DEVELOPMENT REVIEW COMMITTEE (DRC) COMMENT REPORT

PROJECT NAME: Lynx FBO Airport Phase II

CASE NUMBER: UDP-S20011

REQUEST: Site Plan Level II Review: 7,000 Square-Foot Building with 2,000 Canopy Area

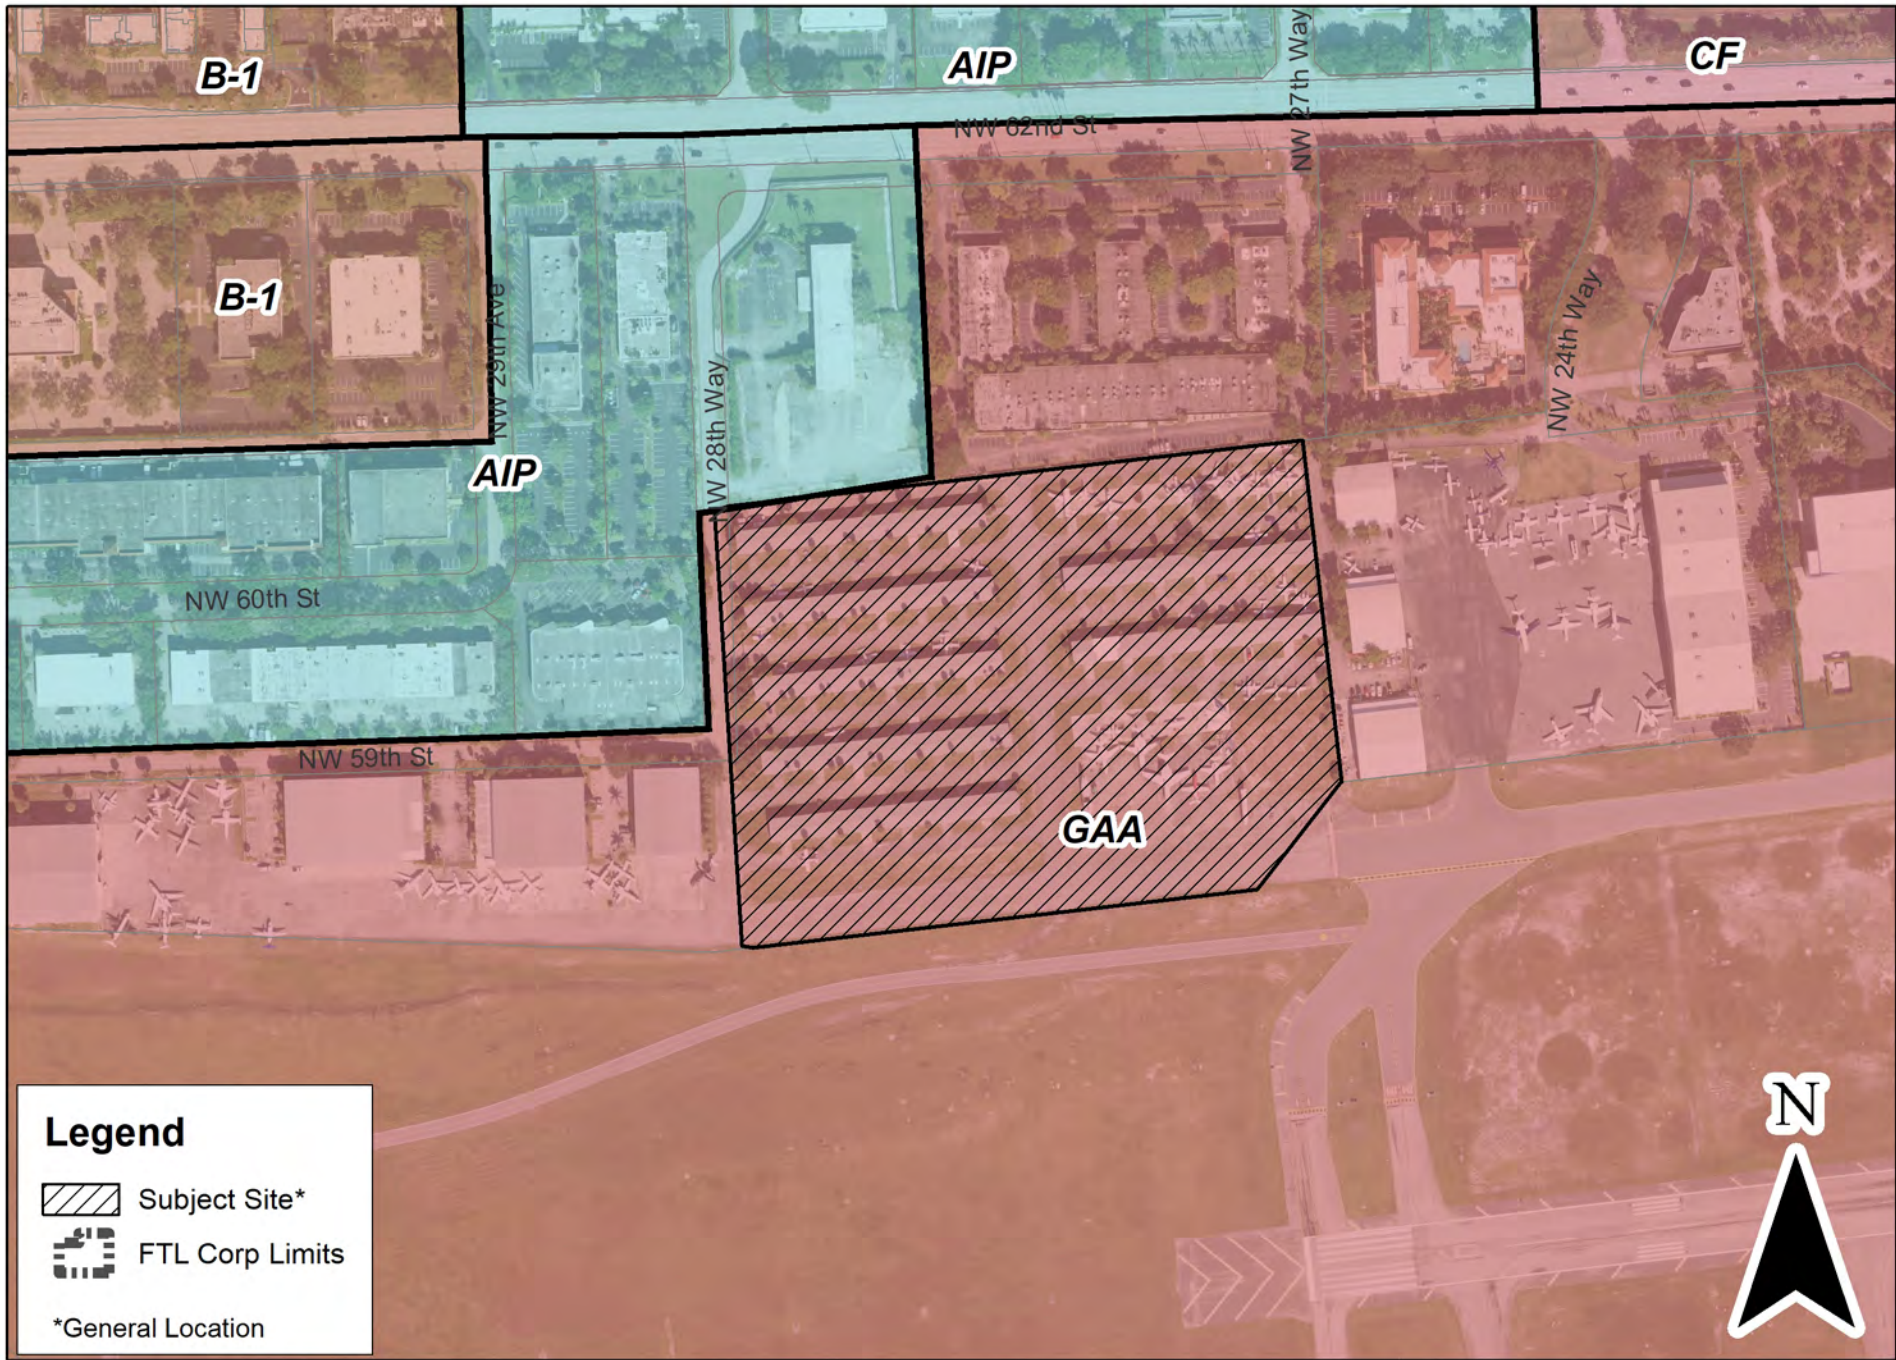
8. Based on the location of the proposed project, the FAA may need to review to determine whether the project is a potential hazard to aviation and in compliance with No. FAR Part 77. To initiate FAA review, access the FAA web page at <https://oeaaa.faa.gov>. FAA approval must be obtained prior to Final-DRC sign-off unless made a condition or otherwise deemed unnecessary by the City Airport Manager or designee.
